Memorandum to the City of Markham Committee of Adjustment

September 16, 2019

File: A/89/19
Address: 68 Poinsetta Drive Thornhill
Applicant: Mohammad Mosleh & Sara Salmanian
Agent: Ali Goudarzi
Hearing Date: Wednesday September 25, 2019

project:
68 POINSETTA DRIVE
drawing:
SITE PLAN
scale:
1/16"=1'
page:
A1

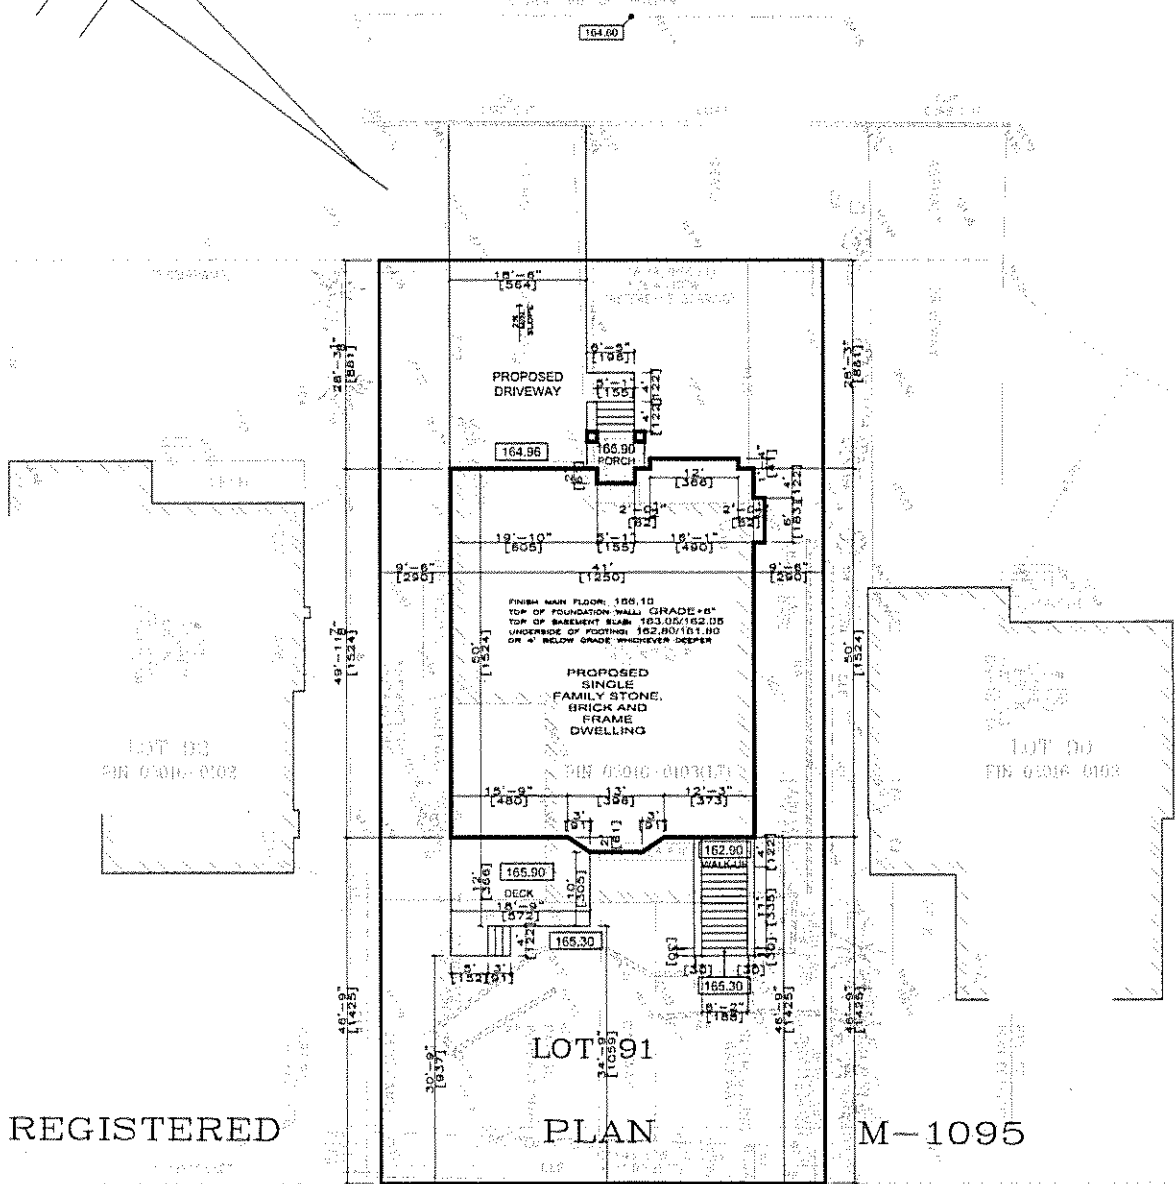
The applicant is requesting relief to permit a floor area ratio of 53.5 percent, whereas the By-law permits a maximum floor area ratio of 50 percent. The variance will facilitate the construction of a two-storey detached dwelling with a floor area of 371.37 m² (3997.39 ft²), whereas the By-law permits a dwelling with a maximum floor area of 348.38 m² (3750.00 ft²). This represents an increase of approximately 22.98 m² (247.39 ft²) or 6.6 percent.

The building layout meets the front, rear, and side setbacks as well as coverage, which ensures the proposed dwelling will be in keeping with the intended scale of residential infill developments for the neighbourhood.

The applicant is requesting relief to permit a maximum building depth of 17.4 m (57.08 ft), whereas the By-law permits a maximum building depth of 16.8 m (55.11 ft). This represents an increase of approximately 0.6 m (1.96 ft).

The variance includes a front covered porch, which adds approximately 1.15 m (3.8 ft) to the overall depth of the building. The main component of the building, excluding the porch, has a depth of 16.25 m (53.31 ft) which complies with the by-law requirement.

Staff believe the variance for maximum building depth to be minor in nature and comparable to development in the surrounding area.

Planning Staff have reviewed the application with respect to Section 45(1) of The Planning Act, R.S.O. 1990, c. P.13, as amended, and are of the opinion that the variances requested meet the four tests of the Planning Act and have no objection. Staff recommend that the Committee consider public input in reaching a decision.
